[Upgrade to Revision]

R20TS0771EJ0100

RH850 Model-Based Development Environment,
Embedded Target for RH850 Multicore + Multirate V5.02.00,
Embedded Target for RH850 Multicore V5.02.00,
Embedded Target for RH850 V5.02.00

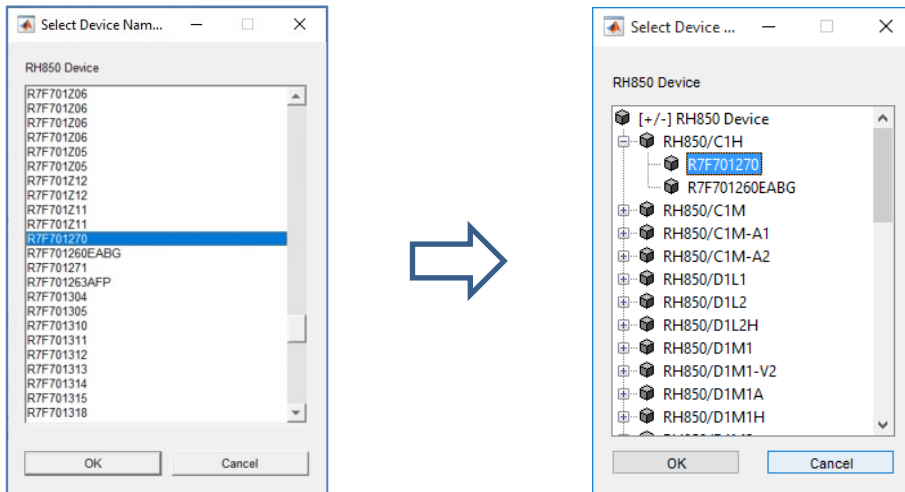
The main changes are as follows.
